**REVISED ADDENDUM
SUPPLEMENTAL
SOURCE AREA INVESTIGATION
WORK PLAN**

327 34th Street, Oakland, California

Re: **Revised Addendum to The Supplemental Source Area Investigation Work Plan**
Former Val Strough Chevrolet
327 34th Street, Oakland, California
Site ID #3035, RO #0000134

PROPOSED LOCATIONS OF SOIL BORINGS
FORMER VAL STROUGH CHEVROLET
327 34TH STREET, OAKLAND, CALIFORNIA
15 NOVEMBER 2007

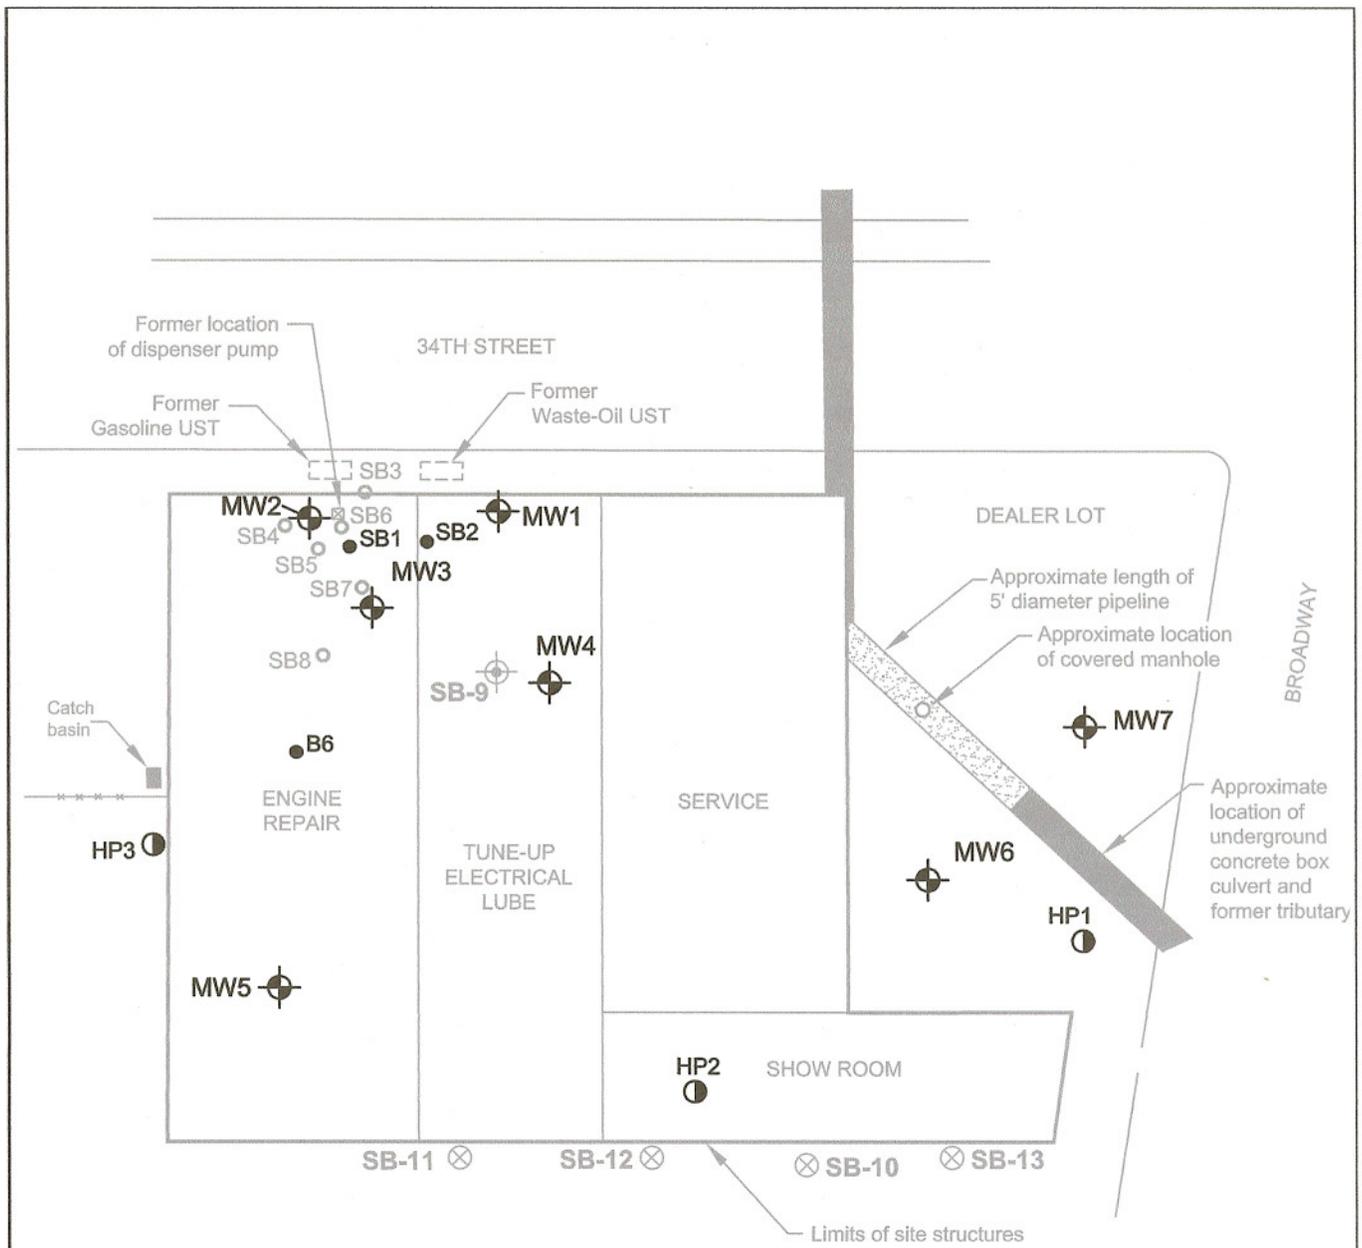
Per the request of Alameda County, soil boring SB-10 will be moved from the immediate vicinity of MW4 to a location between previously proposed borings SB-12 and SB-13 to close the gap between these two borings. Consistent with borings SB-11 through SB-13, the sampling at the new location of SB-10 will consist of a grab groundwater sample at the water table (see Figure 1). The sample nomenclature will be changed in the field and presented accordingly in the report documenting this investigation.
